**24050-04-001**

## **PROPOSED HOUSING DEVELOPMENT AT BALLYMUN, DUBLIN**

### **Stage 1 Quality Audit**

**(Incorporating a DMURS Street Design Audit, and Audits  
of Accessibility, Cycling, Walking and Road Safety)**

**Figure 5.1 – Raised Crossings without drainage detail**

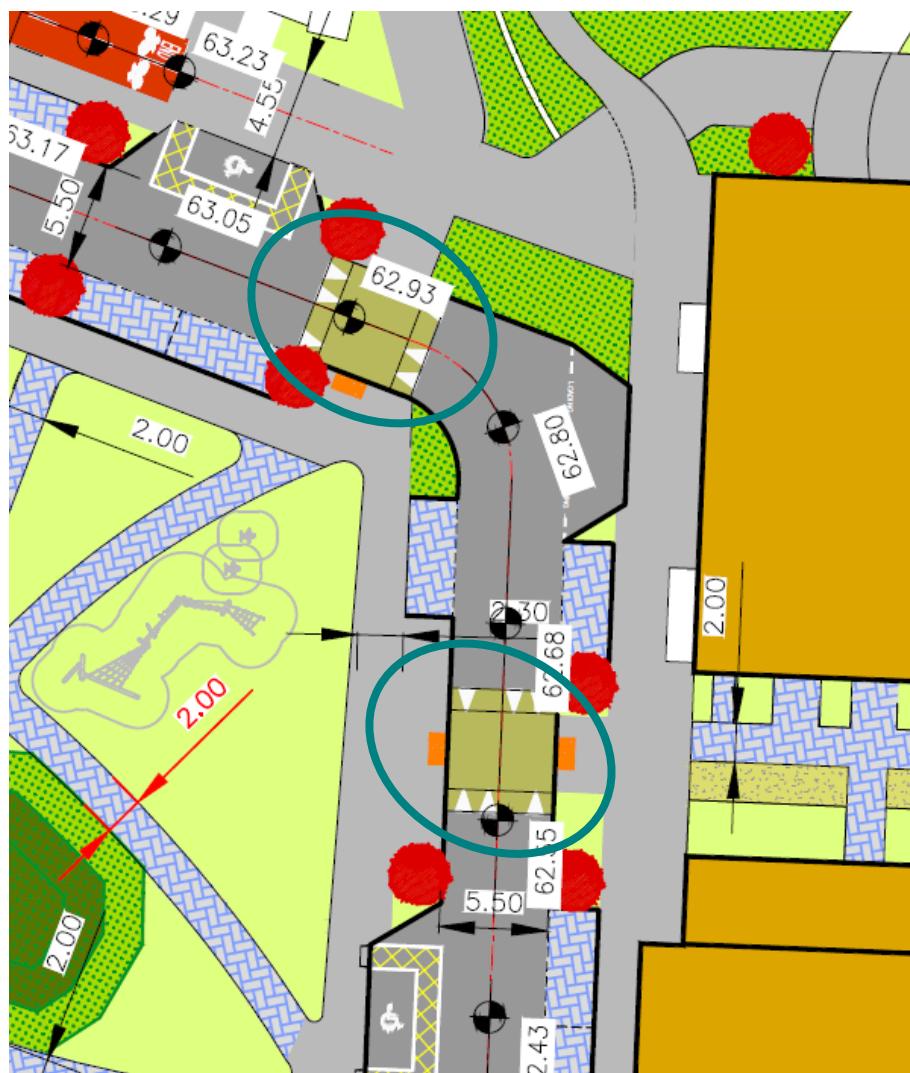
It is noted that the proposed raised tables and grade changes throughout the development including, but not limited to, those in Figure 5.1 & 5.2, do not feature drainage measures on either side of continuous ramps. This lack of drainage may result in ponding water, and/or associated silt forming, which may result in cyclists slipping and falling onto the road with associated injuries.

Ensure that adequate drainage measures are included for all such grade changes.

Figure 5.3 – Visibility Splay interrupted by tree and parking bays

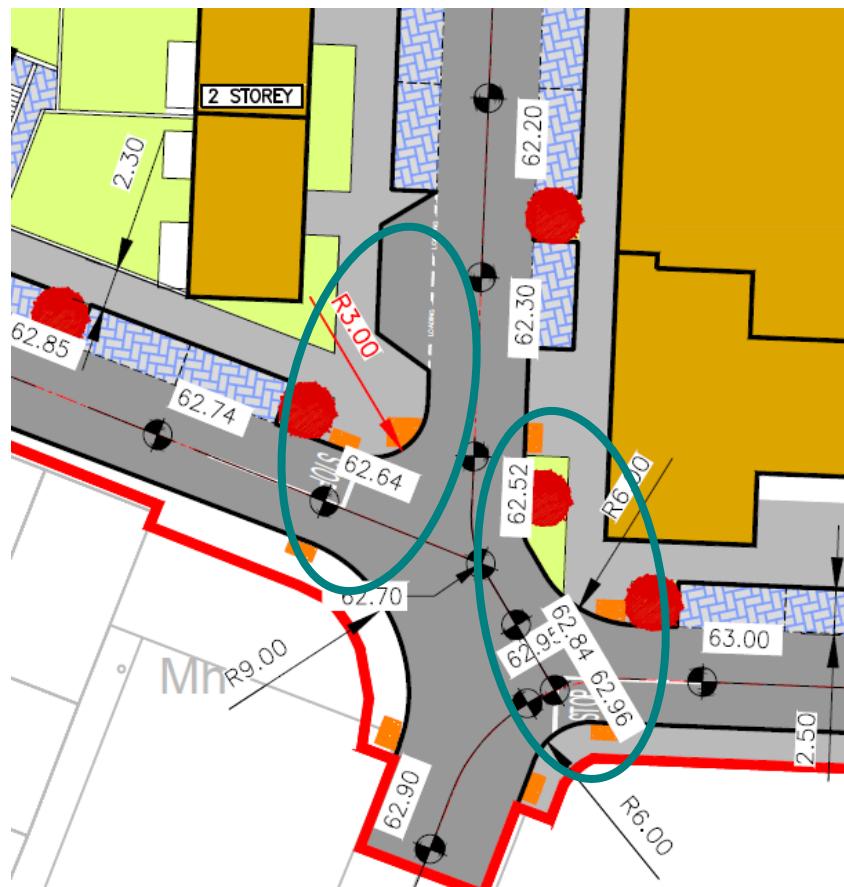
Sightlines at the priority junctions in Figure 5.3 & Figure 5.4 may be interrupted by tree and parked vehicles. This may increase the likelihood of vehicle collisions due to the reduced sightlines. The sightlines at the junction in 5.6 also may be interrupted by parked cars (both formal and informal/illegal parking) as outlined in Figure 5.5 and Figure 5.6.

Ensure adequate visibility splays at all junctions from edge of carriageway. Formalise parking and negate potential for illegal parking.

**Figure 5.7 – Stopping Sight Distance compromised by tree**

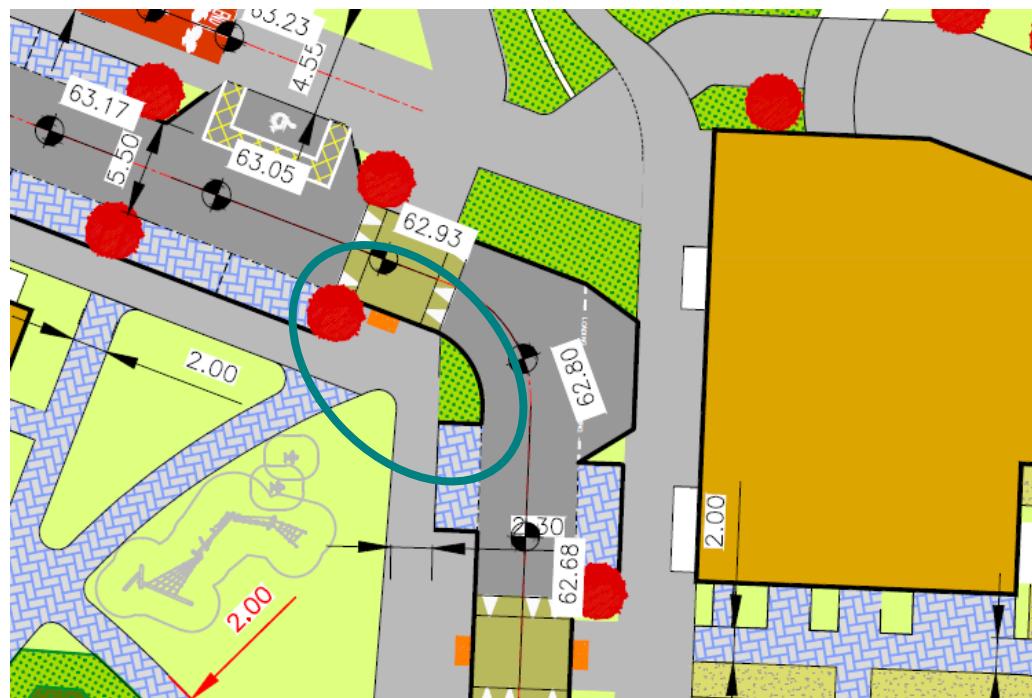
The stopping sight distance (for vehicles approaching from the south) may be obstructed by vehicles parked in the parking bays (Figure 5.7), which may compromise visibility. This may increase the likelihood of vehicle collisions due to the reduced sightlines. Visibility of

pedestrians approaching the priority crossing may also be obscured, potentially causing injuries for users.

Ensure adequate stopping sight distance along all roadways, particularly at bends.

**Figure 5.9 – Island Bus Stop**

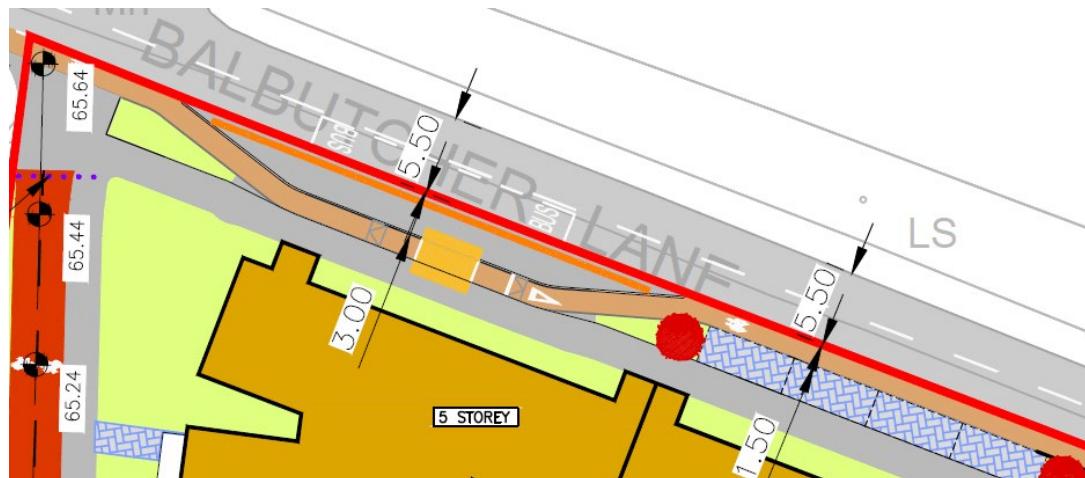
It is unclear if the proposed bus stop bay in Figure 5.9 features Kassel Kerbing or kerbside tactile paving. Lack of Kassel Kerbing at this location may increase the likelihood of buses pulling in mounting kerbs and injuring pedestrians. Lack of bus top kerb edge tactile paving may also increase the likelihood of pedestrians being struck by vehicles if they become disorientated.

Include Kassel Kerbing with offset blister tactile paving.

**Figure 6.3 – Proposed Trees and parking compromising intervisibility of pedestrians and motorists at crossings**

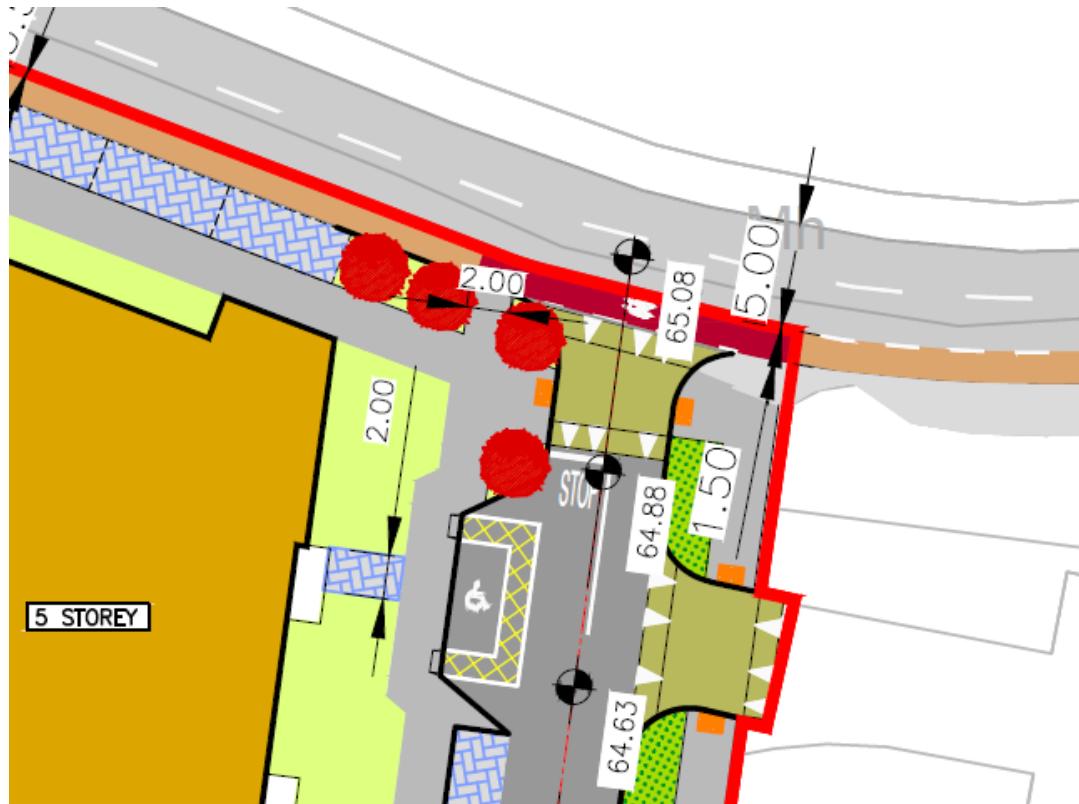
Inter-visibility between pedestrians and drivers and between cyclists and pedestrians at crossings in the proposed development may be significantly compromised by the proposed trees and parking locations. This may increase the risk of collisions and pedestrian injuries at these locations because of trees and parking including, but not limited to, those circled in Figures 6.1 to Figure 6.4.

Ensure adequate inter-visibility between pedestrians and drivers and pedestrians and cyclists at priority crossings. Relocate trees and parking as appropriate.

Figure 7.1 – Raised Crossing Tie-in

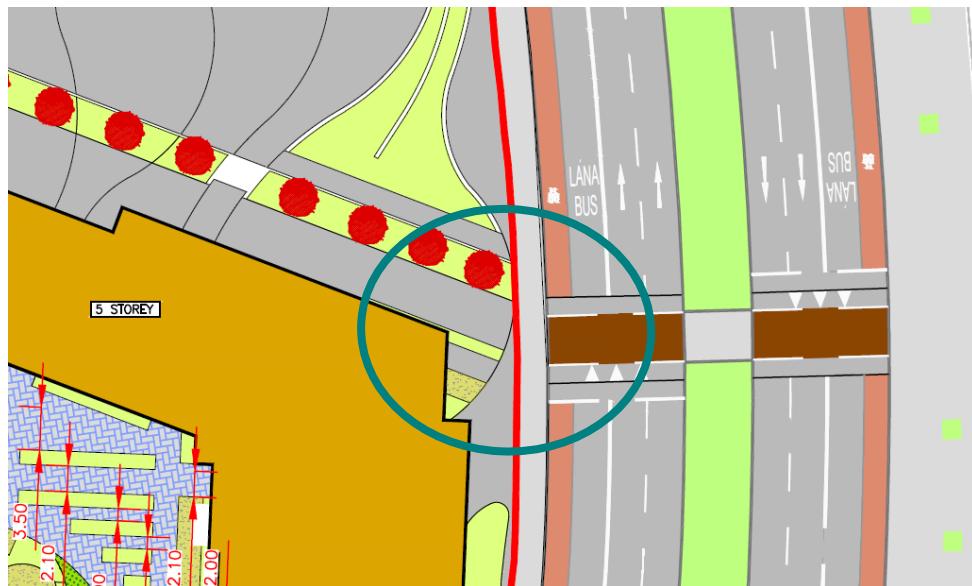
The raised crossing on the R108 may pose problems for cyclists due to the narrow constraint (Figure 7.1). Cyclist arriving at the crossing will mix with pedestrians, at an oblique angle. Trees proposed may also impact the intervisibility between cyclists and pedestrians at this location, increasing the risk of collisions. The existing crossing is also a standard pedestrian crossing which will be too narrow (Figure 7.2) to facilitate a 2-way cycleway. This will result in an increased likelihood of cyclists striking other crossing users.

Ensure adequate space here. Increase width of crossing on R108. Replace with Toucan Crossing. Improve intervisibility at cycleway/footway tie in.

Figure 7.3 – GDA Cycle Network ([www.nationaltransport.ie/wp-content/uploads/2023/01/2022-GDA-Cycle-Network.pdf](http://www.nationaltransport.ie/wp-content/uploads/2023/01/2022-GDA-Cycle-Network.pdf))

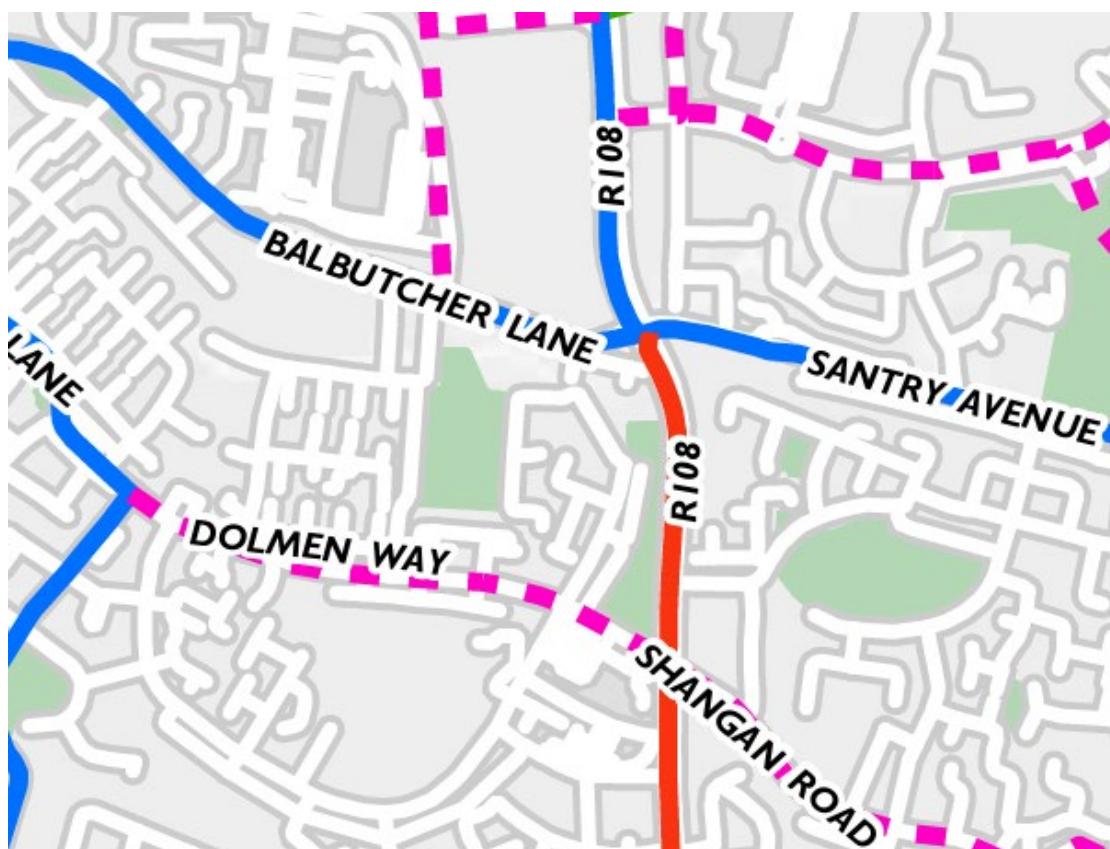
While there is no proposed cycle infrastructure in the development, except the greenway through the development, it is not clear however how the development will tie into the proposed 'Primary Orbital' Cycle Route (red in Figure 7.3) along the R108, the 'Secondary' Route (blue in Figure 7.3) on Balbutcher Lane, or the 'Feeder' Route (dashed pink line in Figure 7.3) on Dolmen Way. A lack of coordination may reduce the effectiveness of these schemes, proposed by Dublin City Council and National Transport Authority, and undermine potential to achieve cyclist desire lines.

Consider wider network impacts of future schemes to support Provide a network of segregated cycleways through the development. Consult with Dublin City Council Active Travel to ensure the development is futureproofed.

**Figure 7.4 – Advisory Cyclelane on Balbutcher Lane**

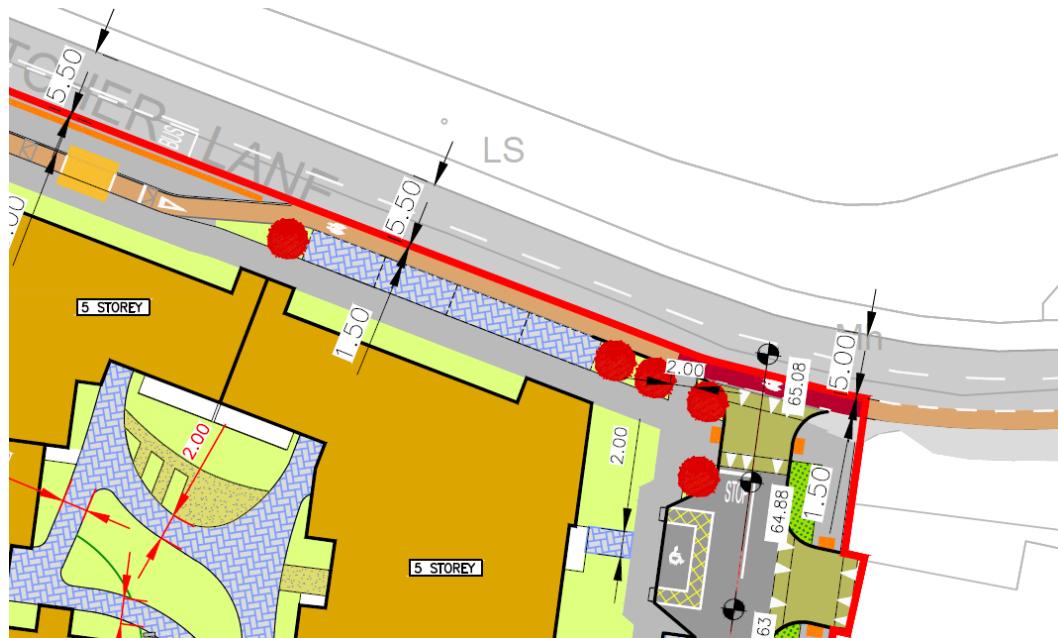
It is proposed to install parallel parking next to advisory cycleway on Balbutcher Lane (Figure 7.4). This may increase the likelihood of collisions between cyclists and vehicles, or the likelihood of cycles being struck by opening car doors.

Remove parking. Provide adequate separation between cyclists and traffic. Consult the National Cycle Manual.

Figure 8.2 – Shared Space Transition

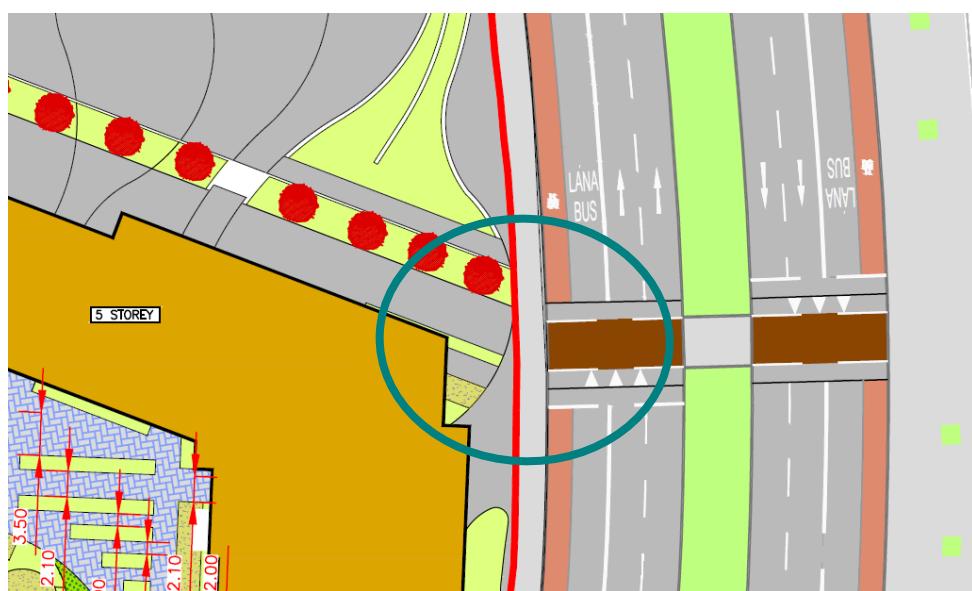
The existing crossing on the R108 (Figure 8.1) does not feature adequate tactile paving to facilitate crossing for those with a vision impairment. There are also no shared space tactile paving indicators at this transition between the cycleway on the R108, the footway on the R108, the existing raised crossing and the proposed cycleway in the development (Figure 8.2). This may result in user confusion or disorientation at this location.

Ensure adequate provision of Tactile Paving and space to navigate this shared space.

**Figure 8.4 – Existing Steps with no Tactile Paving**

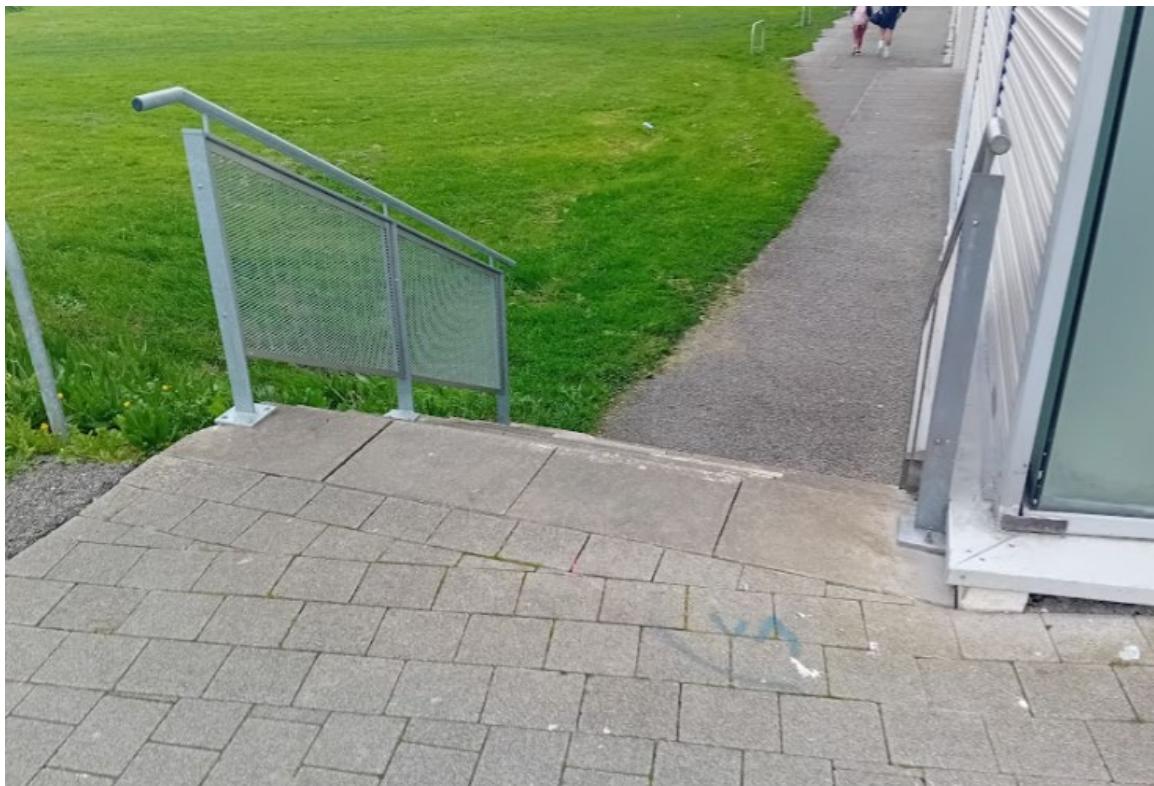
Sets of steps in the development (existing – Figure 8.4) do not feature tactile paving. It is unclear if proposed steps feature railings. Lack of railings and tactile paving may increase the likelihood of injuries for pedestrians with mobility impairments or vision impairments respectively.

Ensure all steps and ramps throughout the development feature railings and appropriate tactile paving.
